Planned Change Request for Shielded Containers

Summary

Figure 1

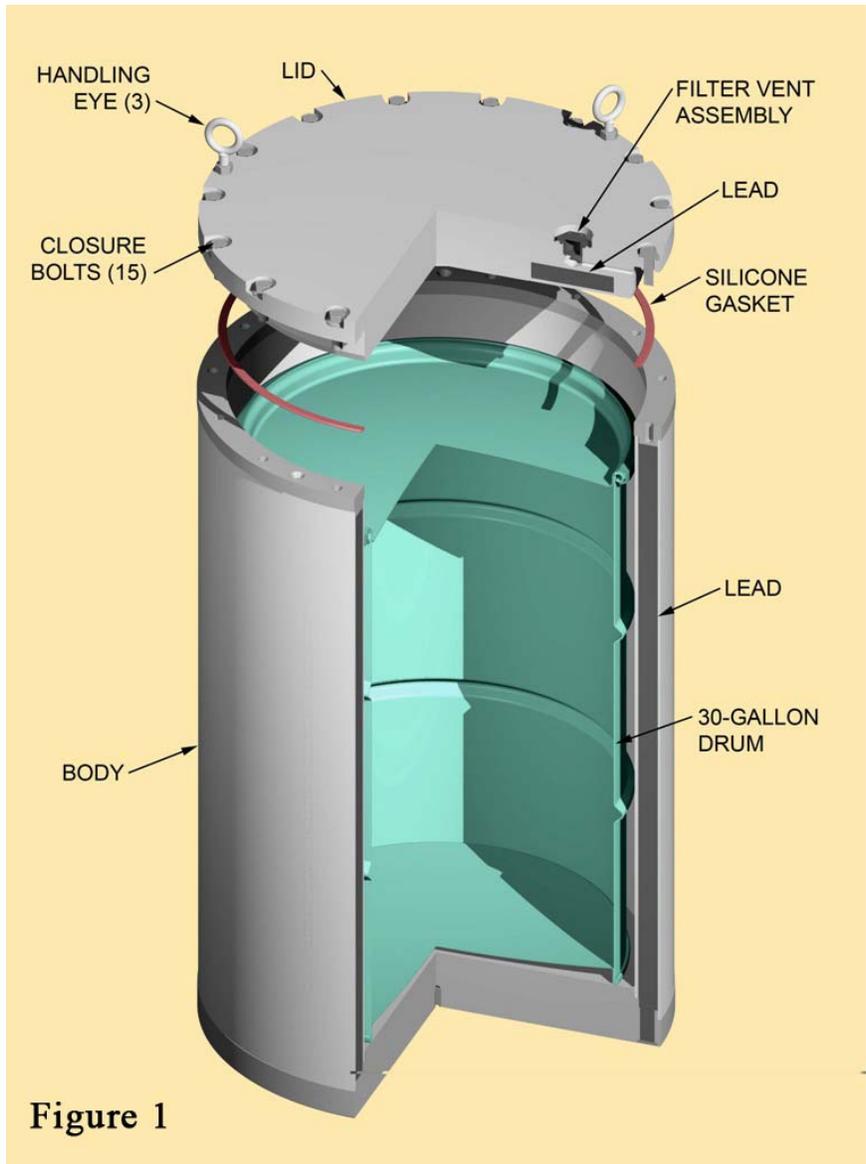
The shielded container has approximately the same exterior dimensions as a 55-gallon drum and is designed to hold a 30-gallon drum. The cylindrical sidewall of the shielded container has 1-inch thick lead shielding sandwiched between a double-walled steel shell as shown in Figure 1. The external wall is 1/8 inch thick, and the internal wall has a thickness of 3/16 inch. The lid and the bottom of the container are made of carbon steel and are 3-in thick. The empty weight of the containers is approximately 1,800 pounds. The shielded container and the inner 30-gallon drum will be vented. The container has been tested to DOT Type 7A and NRC Type B Hypothetical Accident Conditions (HAC) specifications. This will ensure the container is safe for transport and handling and will contain and shield the waste under the most severe accident conditions.

Figure 2

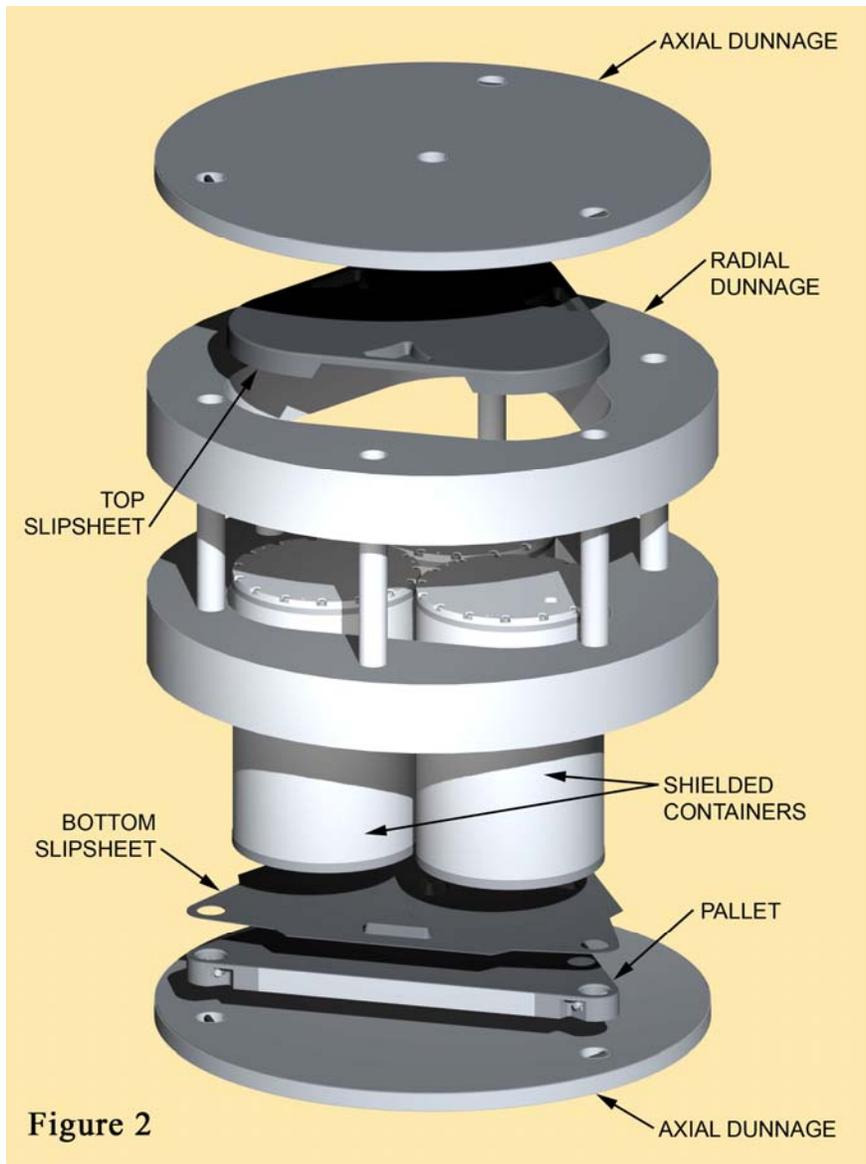
The shielded containers will be assembled in a 3-pack configuration on a triangular pallet, be surrounded by radial and axial dunnage components, and be transported within the existing HalfPACT transportation container. The 3-pack configuration will remain intact throughout transportation and emplacement (Figure 2). The shielded container is designed to stay within the parameters of the HalfPACT design and licensing bases e.g., payload weight, decay heat and radiation dose rate limits. To ensure the robustness of the container, it was subjected to DOT 7A Type A testing that included 4 foot drops of the bare container onto an unyielding surface using four potentially worse-case orientations. As part of the safety analysis, a 3-pack of containers was drop tested 30-feet inside a HalfPACT ICV (Inner Containment Vessel) as part of the Hypothetical Accident Condition (HAC) evaluation required by Title 10 CFR Part 71. The HAC tests evaluate and ensure the containers will adequately shield the RH TRU waste contained within under the most severe accident conditions. The thermal, shielding and criticality evaluations were performed by analysis using similar methodology as presented in the HalfPACT Safety Analysis Report (SAR), RH-TRU 72-B SAR and the TRUPACT II SAR. The tests were successful and the results will be used to demonstrate compliance with all applicable DOT and NRC standards, ultimately leading to certification of the payload container as a DOT 7A, Type A container and as an authorized payload container for shipment within the NRC certified HalfPACT Type B Packaging. DOE is awaiting regulatory approval. The success of this testing proved the container is safe even after being subjected to worst case severe handling or accident condition impacts as specified within the DOT and NRC regulations.
